## NIOWAVE, INC.

July 17, 2018

Subj: Niowave Additional Information for Submission of Amendment 07 to License 21-35144-02

Figure 1. Air handling system flow diagram

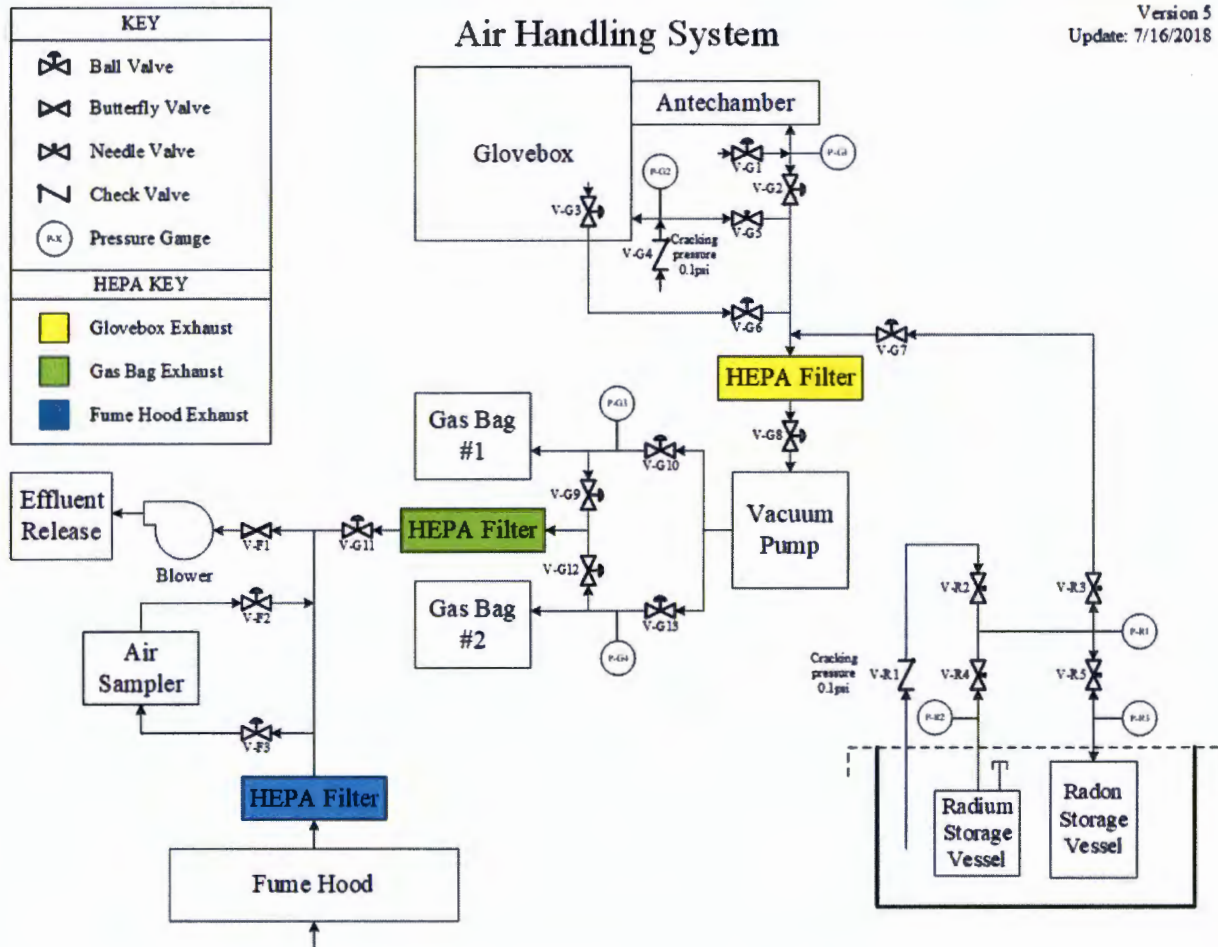
1. Provide additional details on effluent concentration calculations (120 mCi of Rn-222 and progenies) and show that it is less than the release limit.

- Provide additional details on HEPA filtration. What is the efficiency of the filters? How often will we inspect and replace them?

We are installing a HEPA filter inline on the gas bag exhaust to prevent particulates from exiting the gas capture bags (see a green box in Fig.1). The HEPA filter is a Flanders brand filter which is >99% efficient at filtering particles down to 0.3 micron. As such, only Rn-222 will be released from the gas capture bags effluent. The maximum amount of Rn-222 that we can have in a gas bag can be found assuming all the radon in the glovebox is distributed uniformly and all the gas from the antechamber is transferred into the gas bag. Assuming the glove box contains 120 mCi of Rn-222 (the maximum possible amount we are licensed to possess) and taking into account the ratio of the volumes of the glovebox and the antechamber, the maximum amount of Rn-222 which can end up in the gas bag is 11.5 mCi. Using this number as the initial activity, after 60 days of DIS, the activity of Rn-222 will be 2.2E-4 mCi:

There are three HEPA filters in our system (see yellow, green, and blue boxes in Fig. 1). The details on the filters are summarized in Table 2. All the HEPA filters will be inspected annually, or more frequently in case of noticeable changes in system pressure during operation.
